### Previous Information for VTR1000F-V Page 1/3

News Number 97-2-005 Issue Date Nov. 1997

The some specifications and descriptions in the VTR1000F-V Shop Manuals (No. 62MBB00, 63MBB00, 64MBB00 and 69MBB00) are incorrect. Please correct following pages as follows:

Page 9-0 and 9-23 Primary drive gear friction spring.

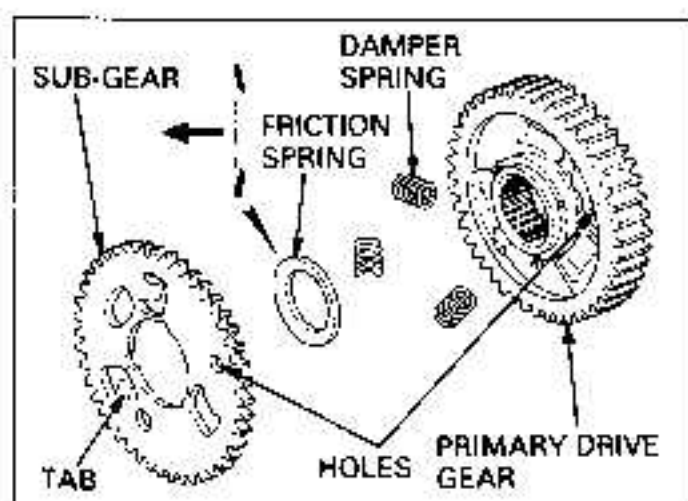
Install the damper springs into the primary drive gear grooves.

Install the friction spring onto the primary drive gear with the concaved side toward the sub-gear.

Apply molybdenum disulfide grease to the primary drive gear and sub-gear sliding surfaces.

Install the sub-gear onto the primary drive gear boss so that the sub-gear tabs are positioned against the damper spring and holes are aligned.
